File No. DOIA 1819-0239

Attached please find a final report with our review comments on the DBH TC3 guidance document. We are well satisfied that the DBH response addresses our comments at an appropriate level of care and detail, and that the new TC 3 guidance report reflects suitably the reviewers' comments.

Review of Interim Guidance for Repairing and Rebuilding Foundations in TC3
 by
 T D O'Rourke, J Bray and M Cubrinovski, 16 April 2012 & 27 April 2012

This report summarizes review comments pertaining to the referenced report, "Guidance for Repairing and Rebuilding Foundations in Technical Category 3 (TC3)." It also contains comments pertaining to the Department of Building and Housing (DBH) response to reviewer comments.

Figure 1. Relationship among Building Damage, Horizontal Strain, and Angular Distortion (after Boscardin and Cording, 1989)

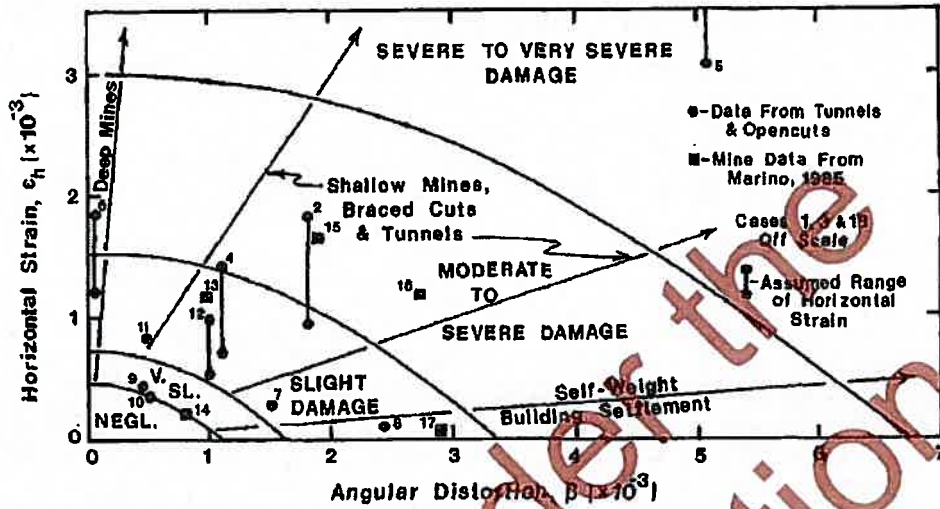
- Ref Fig 1 – diagram showing effects of vertical and horizontal differential ground movements (Boscardin & Cording)
- Combined effect of differential settlement and horizontal ground strain is more damaging – see Table 3.1
- Lateral stretch is most important in terms of building damage
- Stiff foundation slab best at reducing lateral stretch and foundations that allow for horizontal slip
- Refer Japanese examples – successful use of polyethylene sliding layers
- Even a modest slab can provide restraint against lateral strain
- Foundation designs that tend to anchor are less effective

Figure 1 summarizes the effects of vertical and horizontal differential ground movements on buildings developed by Boscardin & Cording (1989). The figure was developed from field measurements and observations as well analytical models of building response to ground movements imposed by adjacent, deep excavations and tunneling, and by mining subsidence. The buildings include unreinforced masonry and timber frame structures. The figure is based on data and observations which were collected and validated over many years, and has been applied successfully on many projects. The figure correlates various degrees of building damage with combined levels of angular distortion (differential settlement divided by the horizontal distance separating the locations of settlement) and horizontal ground strain. Table 1 provides a description of damage categories used in Figure 1, based on the classification of building damage proposed by Burland et al. (1977).

Assuming typical residential building plan dimensions like those in Figure C5.3 in the TC3 guidance document, a lateral stretch of 200 mm over 13 m results in horizontal strain of 15×10^{-3} , which is well above the level of horizontal strain that causes severe to very severe damage. If we assume that "differential settlement would be expected to be approximately half the total settlement" as assumed in relation to Table 3.1 in the document, the angular distortion is calculated as the ratio of 50 mm differential settlement to 13 m or 3.8×10^{-3} , assuming there is no rigid body tilt across the structure. This value exceeds the threshold for moderate to severe damage in Figure 1. When differential settlement is accompanied with horizontal ground strain, the resulting combined effect is more damaging.

the foundation and superstructure design. To reduce the potential damage associated with the upper bounds of moderate to severe ground movement, the horizontal strain and angular distortion need to be on the order of 2×10^{-3} and 4×10^{-3} , respectively. Most of the potential for damage is driven by lateral stretch of the building. To provide protection against horizontal ground strain damage, the foundation and superstructure must be able to reduce the effective lateral stretch in the ground to about 25 mm across the structure. This reduction can be accomplished best by a stiff foundation slab that resists lateral ground strain and by foundation features that allow for horizontal slip between the ground and structure (e.g., plastic slip layer).

Boscardin & Cording (1989) provide analytical results showing that even a modest slab can provide restraint against lateral strain and thereby reduce substantially the influence of horizontal ground strains on building damage. Conversely, foundation designs that tend to anchor the superstructure into the underlying soil through elements that are not interconnected or supplemented with horizontal structural reinforcement are likely to convey ground strain to the structure and be markedly less effective in reducing the detrimental influence of horizontal ground strains.

We have taken these comments into consideration in looking at options for stiffening of foundation slabs and response to lateral stretch. New designs have been proposed that include polythene sliding layers and stiffening of foundations slabs. Specifically, the guidance proposes new options which include:

- Several ground improvement options now include two layers of geogrid to allow the solution to be used in areas of major lateral stretch (eg stabilised crust methods Types 2A and 2B)
- Type 2 surface structure foundations – flexible re-levellable platforms (Type 2A and 2B) both include two layers of polythene as well as two layers of geogrid reinforcement
- Type 3B surface structure foundation – steel beams over pre-stressed concrete beams (stiff platform) includes a polythene slip layer beneath the beams
- Table C5.5 in the Guidance Document provides a summary of which of the surface structure types proposed in the document is able to respond to differing levels of vertical land settlement and lateral stretch
